**ENERGY APPORTIONMENT TOUCH PANEL CONTROLLER UTY- DTGYZ1
SOFTWARE UPDATE L002****Source for this Bulletin**

Japan Service Bulletin VRF-0144 issued August 22, 2016

**Example of Error 17 occur when using a single split system on VRF Network.**

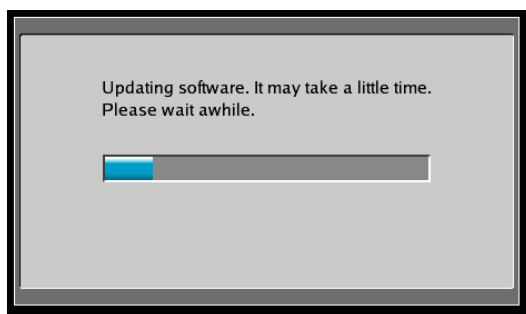
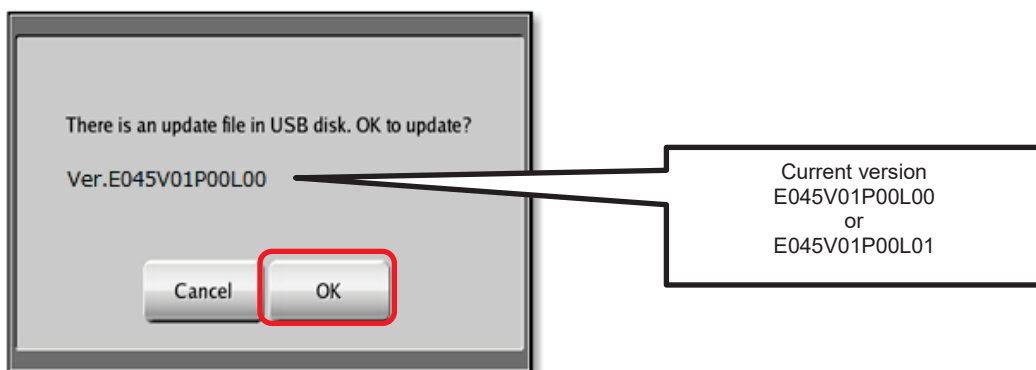
Touch Panel Controller (TPC) may produce Error E17 that is due to the following combined conditions:

1. Electricity Charge Apportionment (UTY-PTGXA) is installed.
2. A Single Split System Converter is connected to the same VRF network.

Error should not be displayed, because the Electricity Charge Apportionment (ECA) function is not available for single split systems.

1. Download the file "gktkp_010002.rpm" from the Fujitsu Portal >> Downloads >> Touch Panel Controller with Internet Optional Software >>Energy Apportionment SOFTWARE UPDATE L002
2. Copy the file to a USB memory stick.
3. Plug the USB memory stick into the TPC while it is powered ON.
4. The update to the TPC will start automatically.
